PROJECT NAME:
Webster Interdisciplinary Science

DESCRIPTION/NOTES:
Counterflashing

SPEC SECTION:
076200

LETTER OF TRANSMITTAL

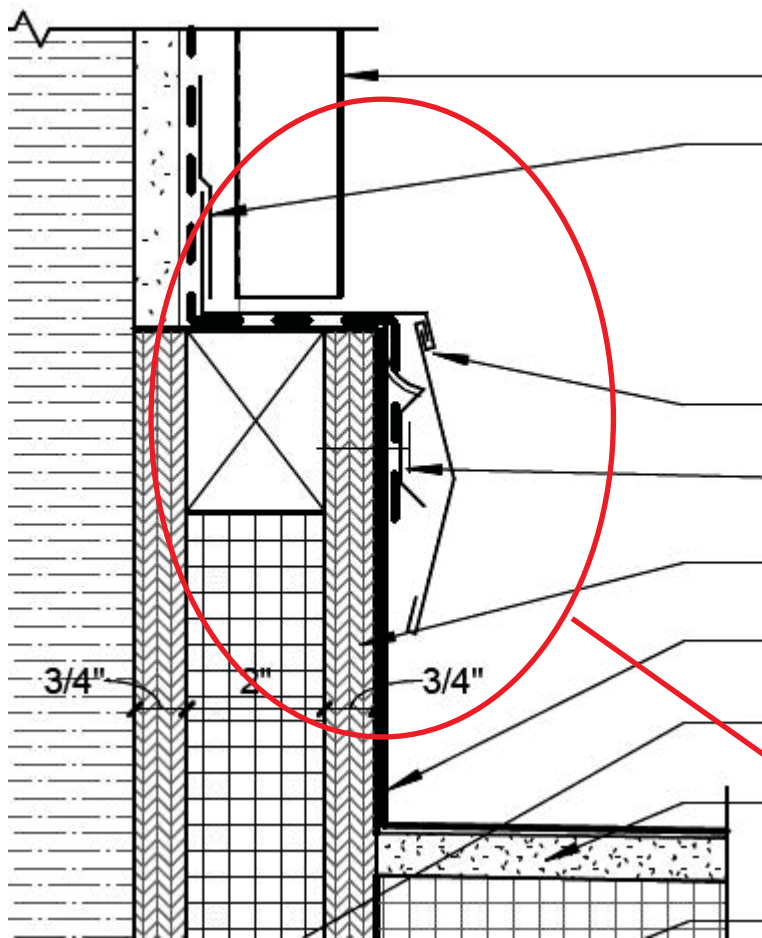
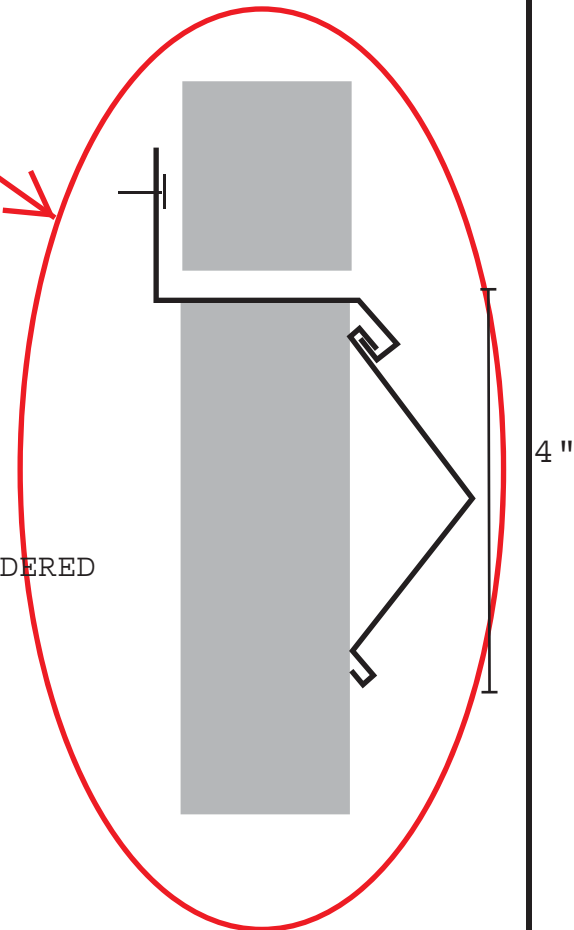
expansion joints to be overlapped 6" min per
